ON-SITE SEWAGE DISPOSAL SYSTEM HOWARD COUNTY HEALTH DEPARTMENT BUREAU OF ENVIRONMENTAL HEALTH

03-317242

SUBDIVISION: Meadowood LOT NUMBER: 55

ADDRESS: 1319 Crows Foot Road PROPERTY OWNER: Selfridge Builders

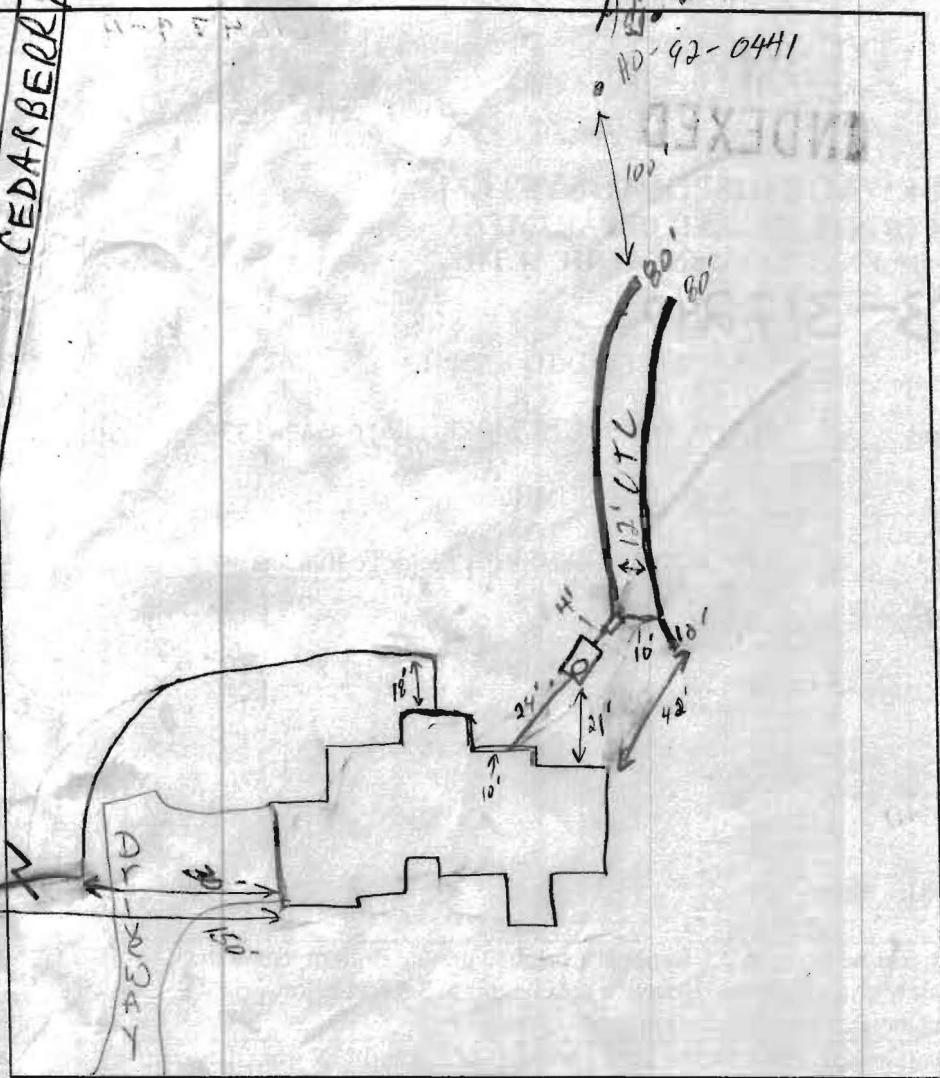
PRE-CONSTRUCTION INSPECTION: 2/3/02 SHA appears 10' to close to neighbors wall.

Can only get 80' on 1st trench (EO)

INSPECTION COMMENTS: 2/5/02 Came back. Oden Sr & Jr very abusive. Stuart & I called Mark to verify ok for "t" out of d.b. for 10' of first trench running parallel toward front of house & 80' toward the rear lot line. (SO/KG) 2/4/02 ok to cover except house conn (not made yet) & 2/11/02 house conn made (S)
